Subject: BAR Action December 17, 2013

RE: Certificate of Appropriateness Application BAR-13-12-01 217 West High Street Tax Map 33 Parcel 131 Nichola Properties, LLC, Owner/ Byrd Leavell, Applicant Add residential unit in garage structure

CITY OF CHARLOTTESVILLE BOARD OF ARCHITECTURAL REVIEW STAFF REPORT December 17, 2013

BAR-13-12-01
217 West High Street
Tax Map 33 Parcel 131
Nichola Properties, LLC, Owner/ Byrd Leavell, Applicant
Add residential unit in garage structure

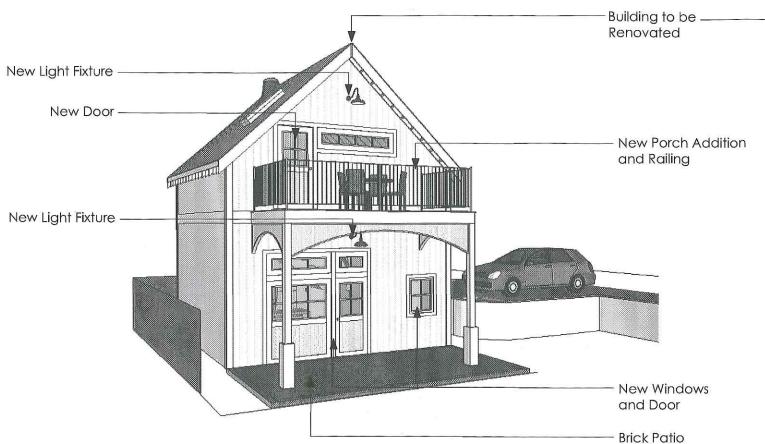
The window muntins should be confirmed as SDL's permanently affixed to the exterior. \checkmark

The window panes in the garage opening should be square or vertical, not horizontal, in keeping with the character of surrounding buildings. The horizontal window on the second floor is an unusual shape.
